**MONTGOMERY COUNTY HISTORIC PRESERVATION COMMISSION**  
**STAFF REPORT**

<b>Address:</b>	102 East Kirke Street, Chevy Chase	<b>Meeting Date:</b>	5/22/2024
<b>Resource:</b>	Outstanding Resource <b>Chevy Chase Village Historic District</b>	<b>Report Date:</b>	5/15/2024
<b>Applicant:</b>	Britt & Will Williams (Luke Olson, Architect)	<b>Public Notice:</b>	5/8/2024
<b>Review:</b>	HAWP	<b>Tax Credit:</b>	n/a
<b>Permit No.:</b>	1067931	<b>Staff:</b>	Dan Bruechert
<b>Proposal:</b>	Demolition of garage and construction of new garage, partial demolition, fenestration alteration, new two-story rear addition, hardscape alterations, tree removal, pool installation.

**STAFF RECOMMENDATION**

PROPOSED FIRST FLOOR PLAN  
 PROPOSED HOUSE FOOTPRINT : +/- 3,424 S.F.  
 PROPOSED GARAGE FOOTPRINT : +/- 531 S.F.

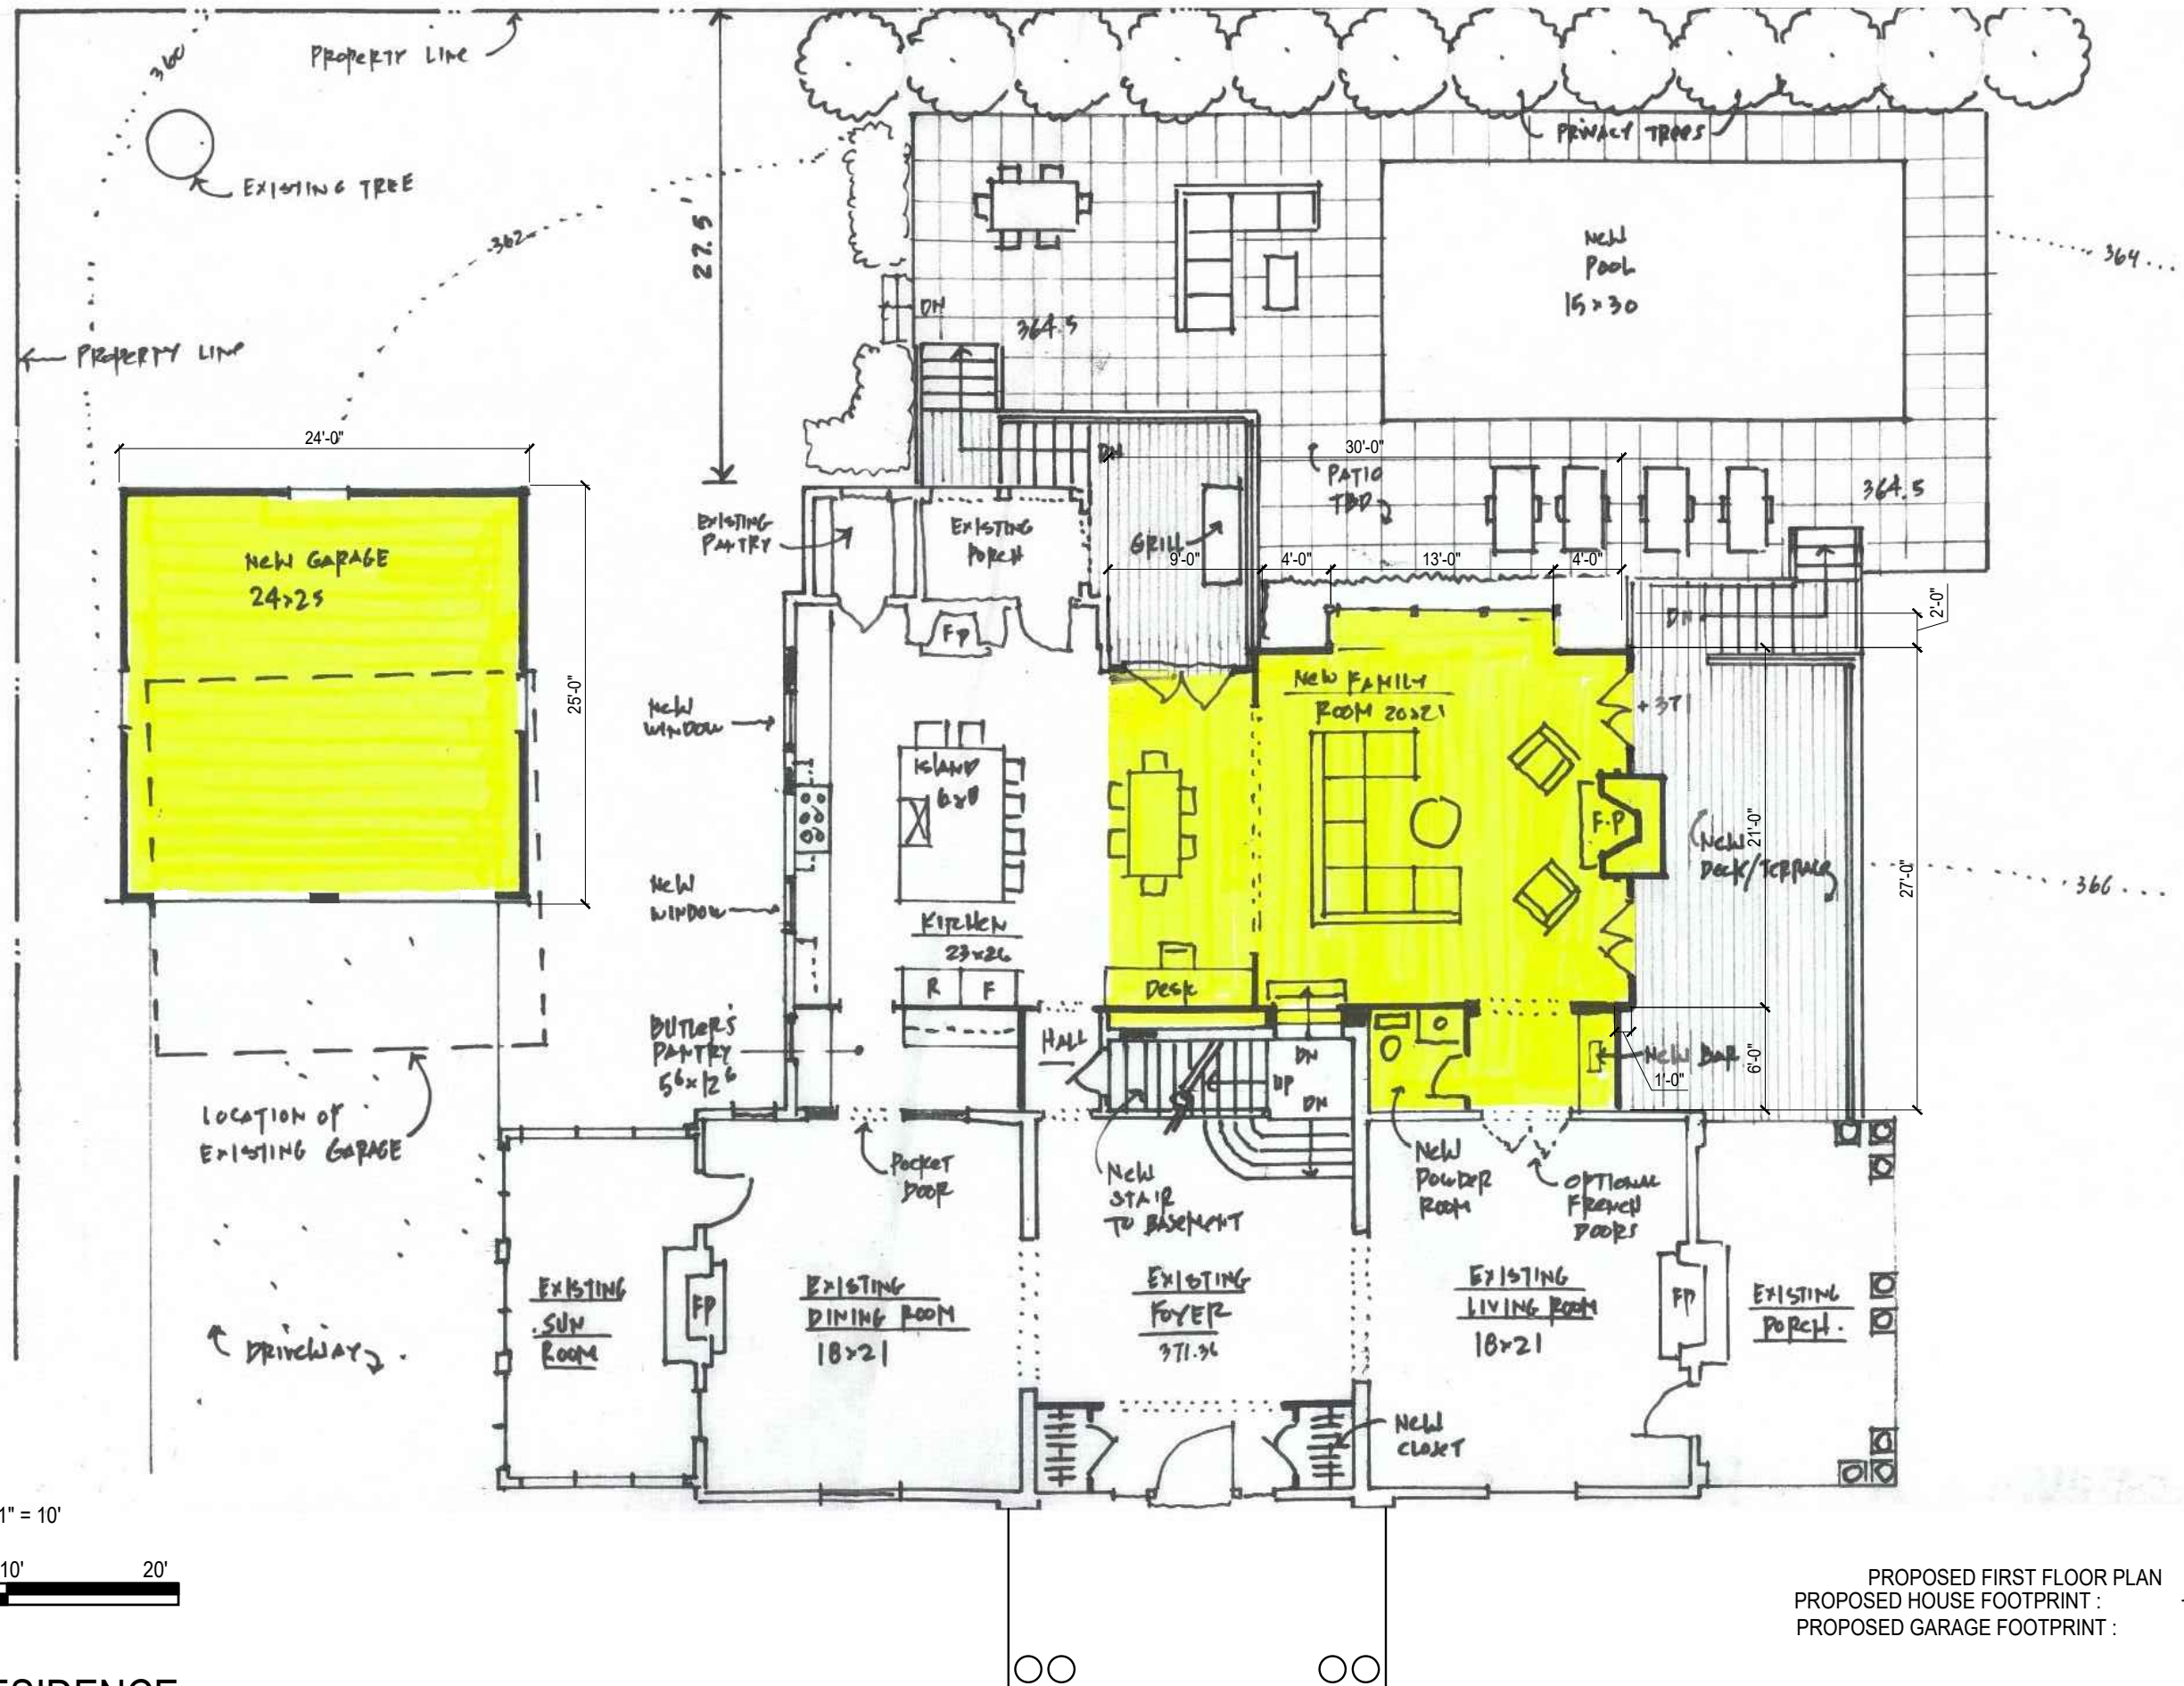
To the west of the proposed addition, the applicant proposes to construct a deck using a composite material measuring approximately 31' × 12' (thirty-one feet wide by twelve feet deep), including the stairs. Submitted materials for the deck include both Acre and Aeratis decking (the application does not identify which material is proposed for the side deck), and proposes an extruded cellular PVC railing system. While the notation on the drawings still shows "New Deck +/- 439 SF," the front of the deck now aligns with the second column on the historic porch instead of the first; narrowing the deck by approximately 1'-2' (one to two feet).

Staff finds the slight modification to the porch is consistent with the HPC’s feedback and recommends the HPC approve the size and placement of the porch based on their findings. However, Staff does not find the materials are appropriate for an ‘Outstanding’ resource in the Chevy Chase Village Historic District. Staff notes the *Design Guidelines* state that the principles apply to ‘Contributing’ and ‘Outstanding’ resources equally (unless otherwise stated in the guideline), however, the *Design Guidelines* also dictate the structures with the highest level of significance should receive the most detailed level of review. Decks are to be reviewed under *moderate scrutiny* as defined in the *Design Guidelines*, which requires preserving the integrity of the resource, but also permits the use of “compatible new materials, rather than the original building materials.” To date, the HPC has not found Acre to be a compatible substitute for wood in any instance. The HPC has selectively allowed Aeratis decking and porch flooring, but only in instances where the substitute decking does not touch historic material (either on ‘Non-Contributing’ Resources or where the deck/porch abuts an addition). Here, the deck will abut new construction, but it also touches the historic side porch. For this reason, Staff finds that neither of the proposed substitute decking materials nor the proposed cellular PVC railing are appropriate materials. Staff recommends the HPC add a condition to the approval of this HAWP that requires the new decking and railing be wood. Final approval authority to verify this condition has been satisfied can be delegated to Staff.

1. The proposed substitute materials for the west deck and railing are not appropriate and must be wood. Final approval authority to verify this condition has been satisfied is delegated to Staff.
2. Detailed drawings of the existing and proposed sunroom windows must be submitted with the final approval documents. Final approval authority to determine the replacement window is appropriate is delegated to Staff;

PROPOSED GARAGE PLAN

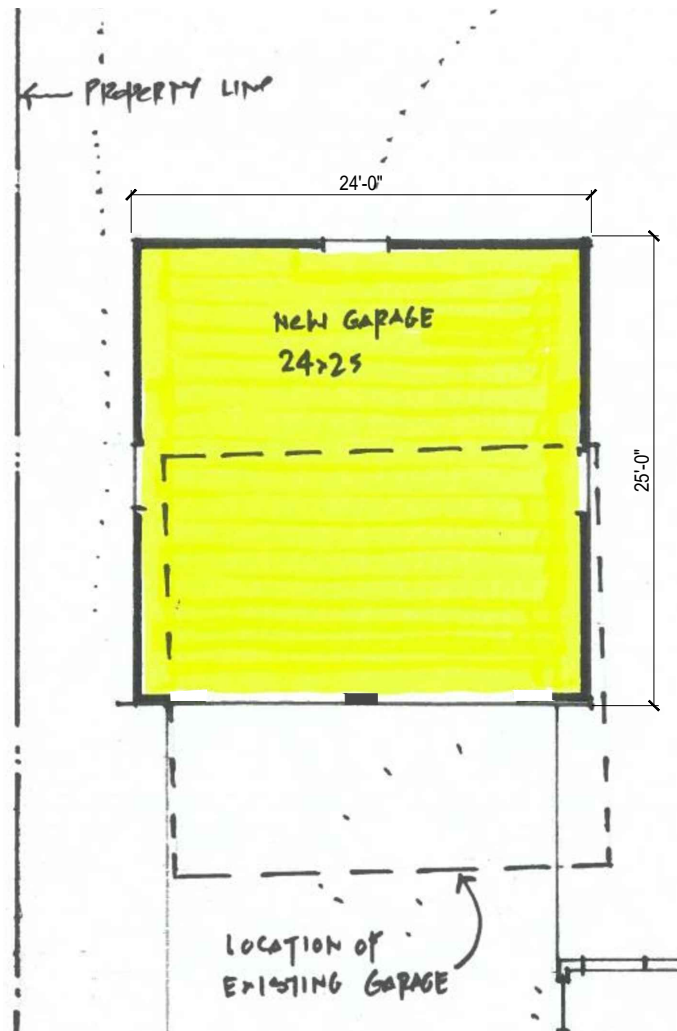
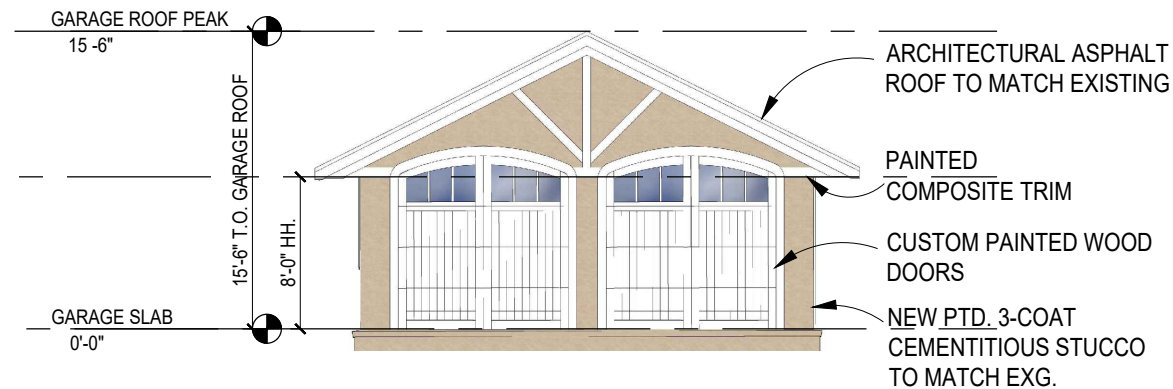
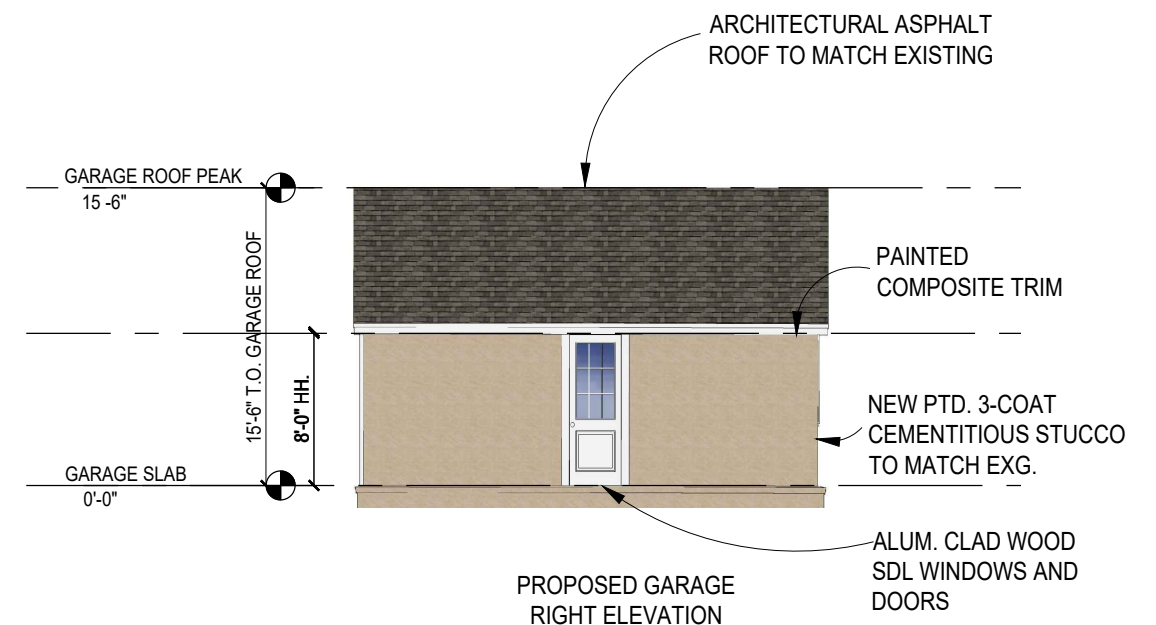
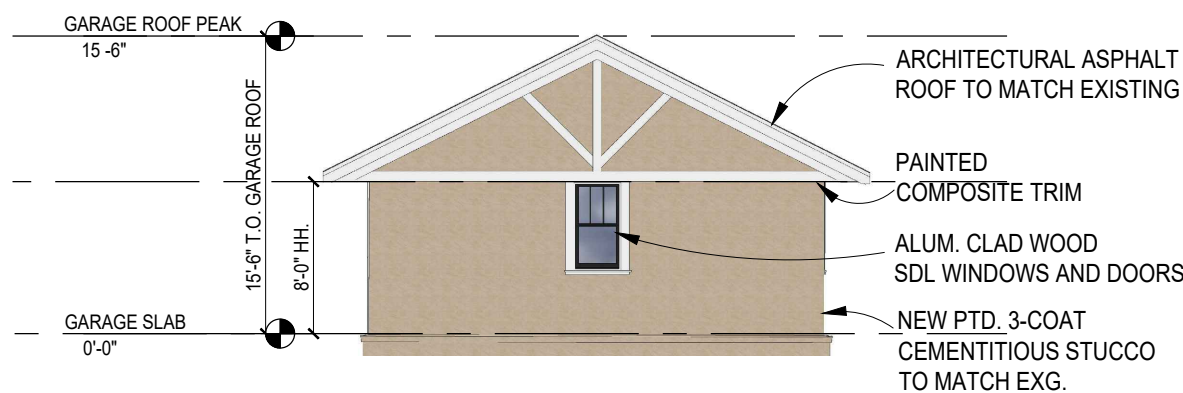
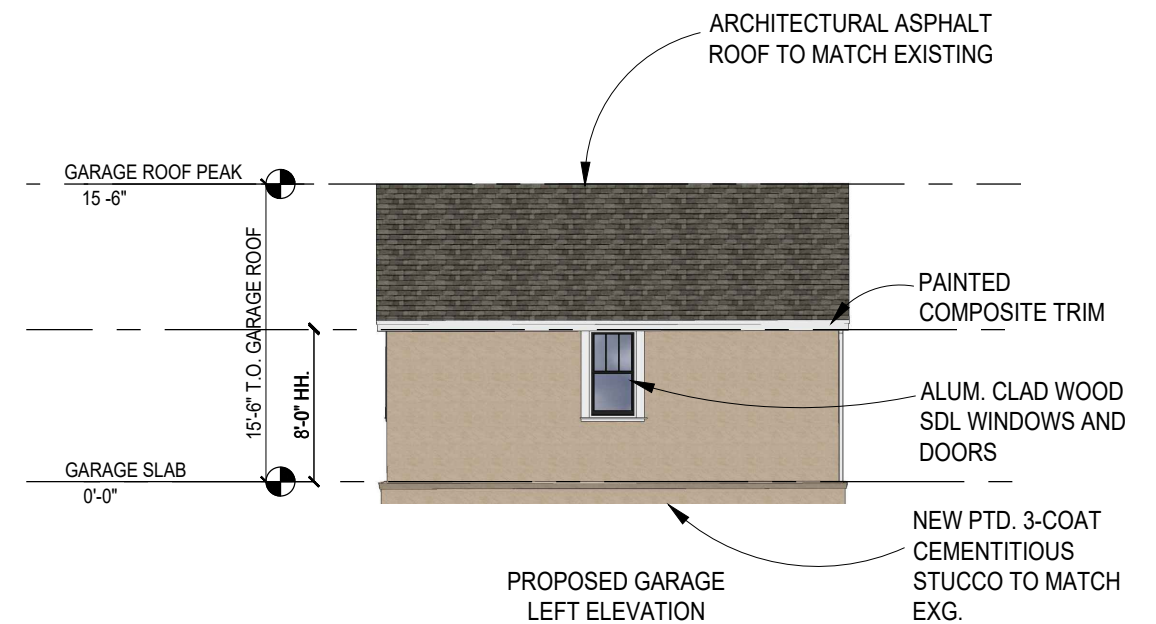
The applicant proposes to extend the existing driveway by several feet and construct a new, two-car garage. The proposed garage has a front gable roof, with stucco siding, composite trim, and custom wood doors. Each of the gable ends includes the half-timber design from the historic garage. The garage also has aluminum-clad windows and doors which match proposed in the addition, discussed above.

primary considerations should be on the proposed massing and scale. Staff finds the general size, placement, and form of the garage are appropriate for the character of the site and surrounding district. Staff additionally finds the design embellishments including the half-timbering, and decorative painted wood doors are consistent with the HPC's feedback at the Preliminary Consultation and Staff recommends the HPC approve the HAWP under the *Design Guidelines* and 24A-8(b)(2) and Standards 2, 9, and 10.
